NOTICE OF VIOLATION

On July 23, 2024, Energy Safety conducted an inspection of Southern California Edison Company's WMP initiatives in the vicinity of the city of Lake Elsinore, California. The inspection report is enclosed herewith. Energy Safety found the following violation (s):

INSPECTION REPORT

Item1IA1img1: View of bare wire construction where covered conductor installation was reported as completed.

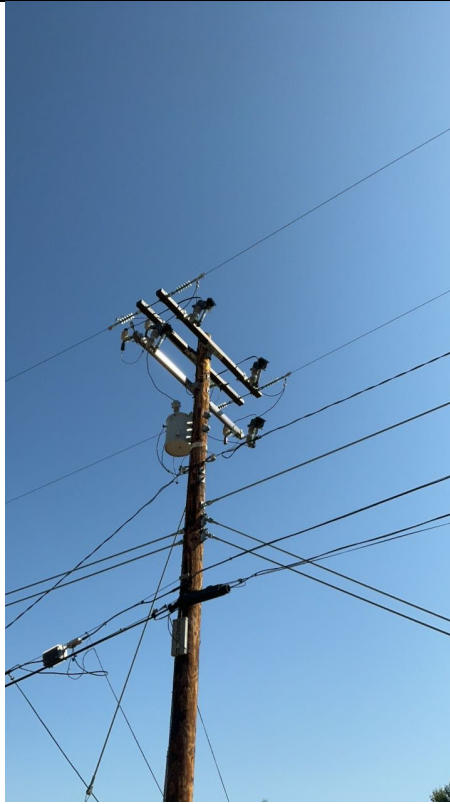
On Pole ID 1668407E, Grid Hardening ID TD2121976-1668407E, at 18962-18998 Dexter Ave, Lake Elsinore, CA, 92532, USA, 33.68649786411026, 117.32865556319356, the inspector observed that that the pole did not have covered conductors installed where covered conductor installation was reported as completed by SCE. The inspector's observation is documented in Violation 1 photographs, which are attachments to this report. Photo numbers Item1GIimg1, Item1GIimg2, and Item1IA1img1 depict bare conductor where covered conductor installation was reported as completed.

1. Southern California Edison Company's 2023 WMP Covered Conductor (8.1.2.1.1) work was identified as complete at this location.
2. A bare conductor was observed at this location.
3. No covered conductor was observed at the provided location.
